Re: *Proposed Leonidas Group of Virgil, LLC Starr Road Residential PUD - Site Plan Review*
CHA Project No. 19646-5005-30300

Re: Leonidas Group – Proposed Starr Road Residential PUD
CHA Project Review Letter of July 16, 2018 & Revised Site Plan Submittals

PROPOSED EMERGENCY ACCESS GATE

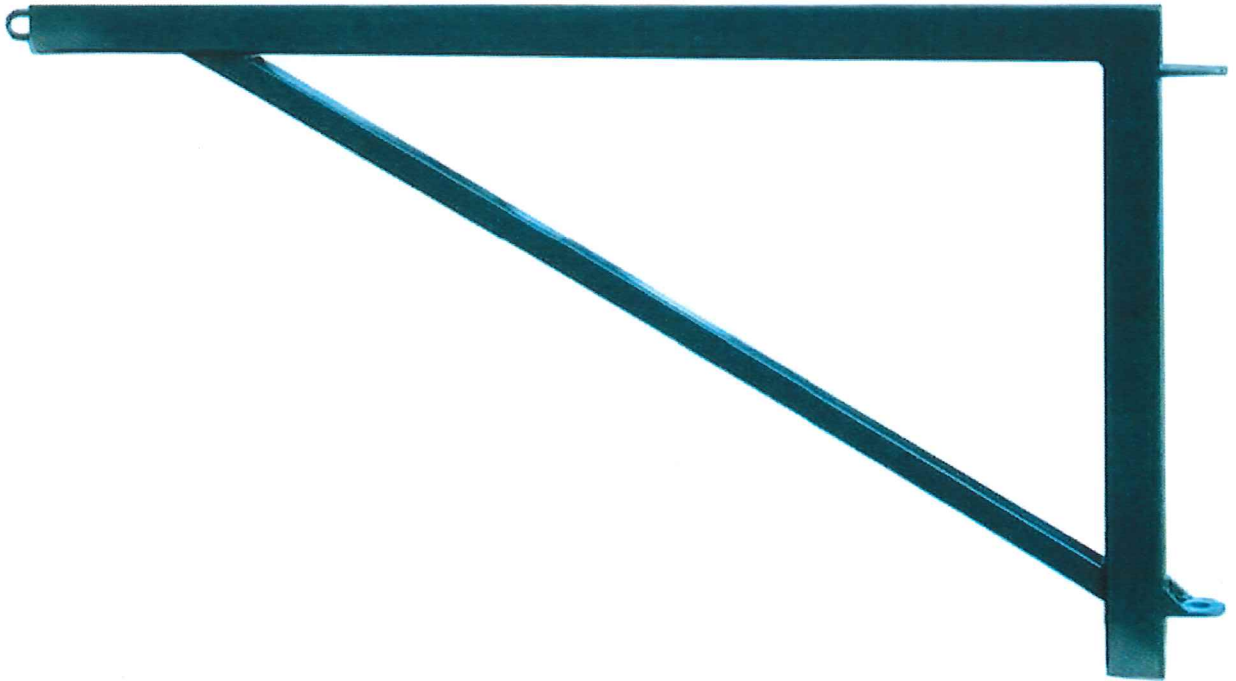
18. Details for the emergency access control at the connection with Parti Drive shall be provided. The roadway connection to Parti Drive will need to be reviewed, approved, and permitted by the Town's Highway Superintendent.

The emergency access control concept has been discussed with the Town Highway Superintendent and a schematic layout is attached to this letter. It will consist of a swing-type tube steel gate with a motorized operator and access control with a keypad, fob, or cell phone controller. Once approved by the Highway Superintendent, the details will be added to the final plans set.
